NFPA Technical Committee on Fixed Guideway Transit and Passenger Rail Systems (FKT-AAA)

NFPA 130 FIRST DRAFT MEETING AGENDA

October 26-29, 2020

Figure A.6.3.2.1 Unobstructed Clear Width for Trainway Walkway.

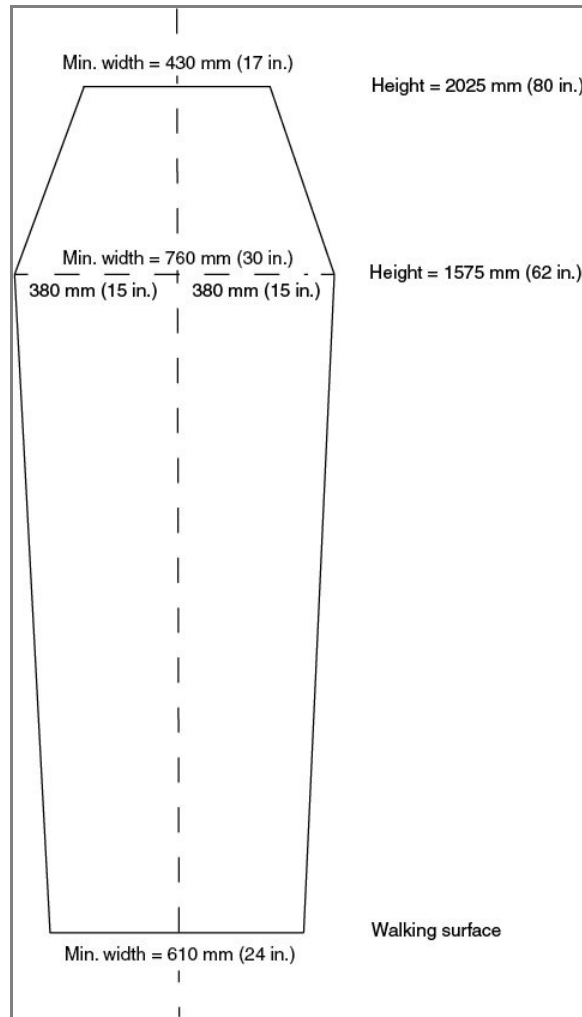
Statement of Problem and Substantiation for Public Input

Figure C.1.3 Center Platform Station.

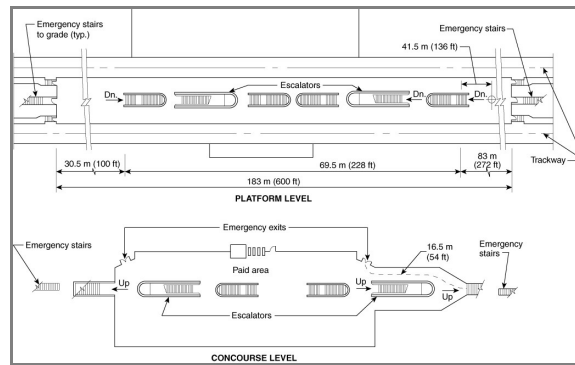
C.2.2.1 _ Center-Platform Station Sample Calculation. **Station**

Figure C Figure C .1.4 Side 2.2.2 Side -Platform Station.

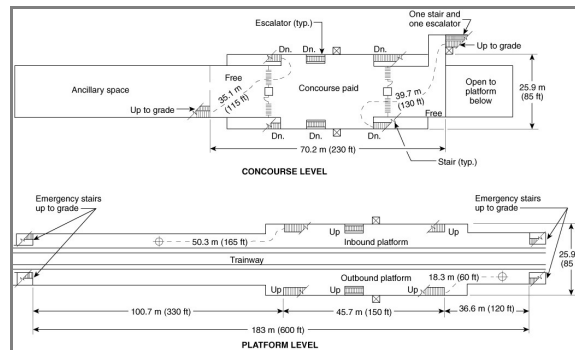
C.1 2 .4 2.2 Side-Platform Station Sample Calculation. Station
